## Urgent Field Safety Notice

### Single Chamber Temporary External Pacemaker 53401

June 2018

Medtronic reference: FA824

**FIGURE 1- updated firmware displayed in this image**

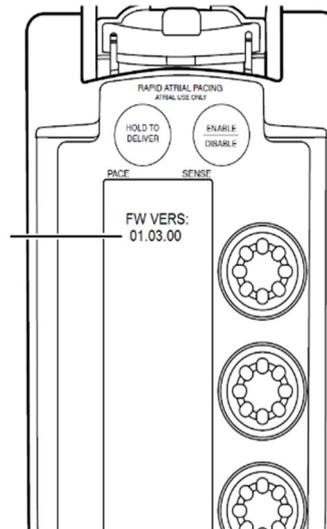
1. Verify whether 53401 EPGs in your possession are affected
2. If your EPG is affected, complete the following:
  - Determine if the EPG firmware has been updated.
    - Power unit on and view firmware version (Figure 1 below).
    - If firmware version is 01.03.00 or greater, EPG firmware has been updated with correction for this issue. No other action is recommended.
    - If firmware version is 01.02.00, EPG firmware has not been updated. You may arrange to have your Medtronic Service Center update the EPG firmware at no charge.

During power up process, Firmware Version will be displayed for 2 seconds

Recently, Medtronic received approval for a firmware correction that prevents occurrence of this issue. Medtronic recommends customers send affected devices to Medtronic Service to update the firmware to prevent this issue.
